Groundwater modelling peer review

INDEPENDENT PEER REVIEW STATEMENT

ATTENTION:	Dr Doug Weatherill, Associate Groundwater Modeller, EMM Consulting	
FROM:	Hugh Middlemis, Principal Groundwater Engineer, HydroGeoLogic Pty Ltd	
REFERENCES:	6 April 2022	Balranald Mineral Sands Project MOD1 Groundwater Modelling
SUBJECT:	Independent Peer Review of Balranald MOD1 Groundwater Model 'BAL3.0'

Figure 1 - BAL3.0 conceptual model, with layers indicated schematically (after EMM 2022 Figure 1.3)

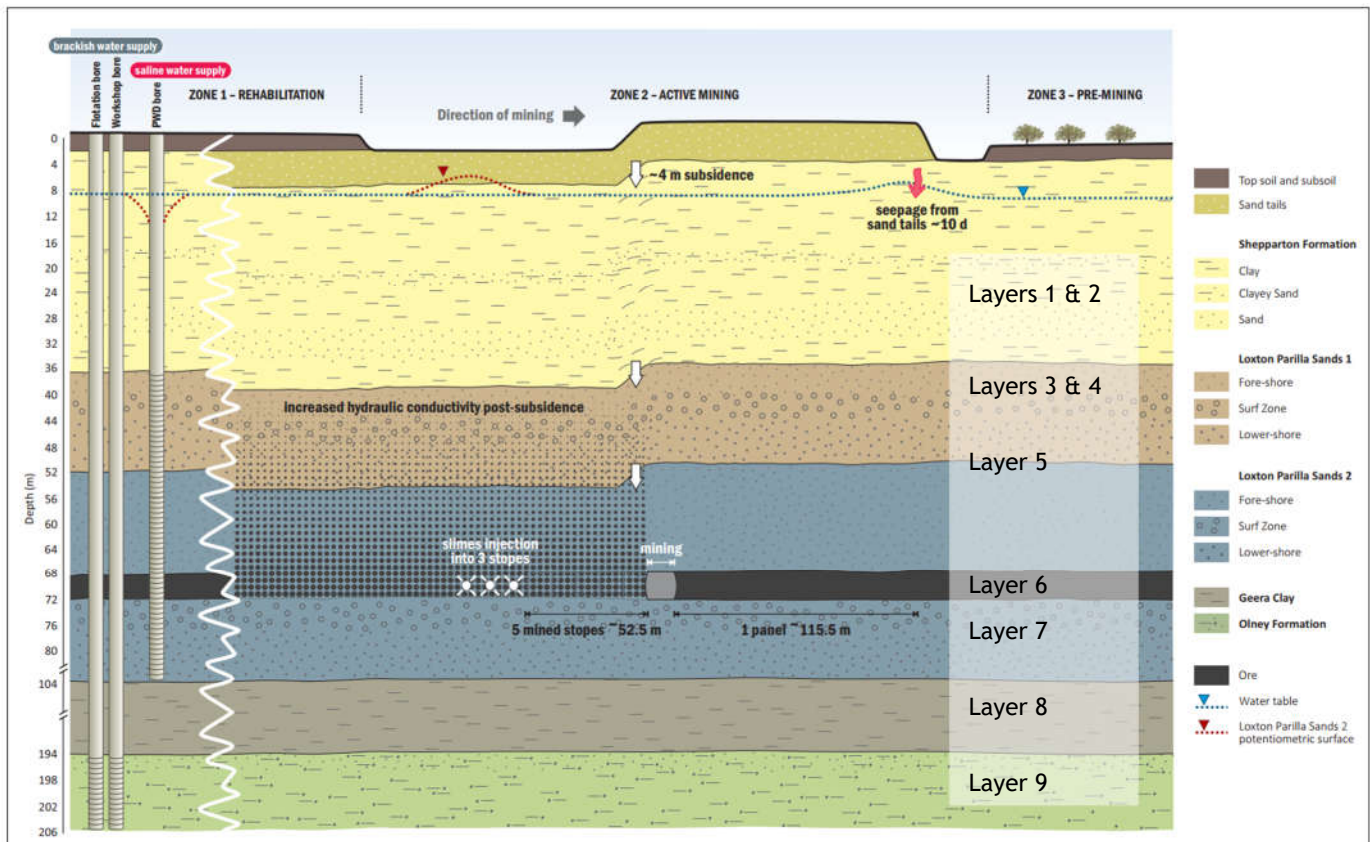
The BAL2.0 hydrogeochemically-constrained conceptual hydrogeological model (Jacobs 2015, figure 2.28) has been retained for BAL3.0, along with the numerical model domain, layer structure and boundary conditions from the BAL2 model (Figure 1). These aspects have previously been peer reviewed (Middlemis 2015a,b) and found to be fit for purpose.
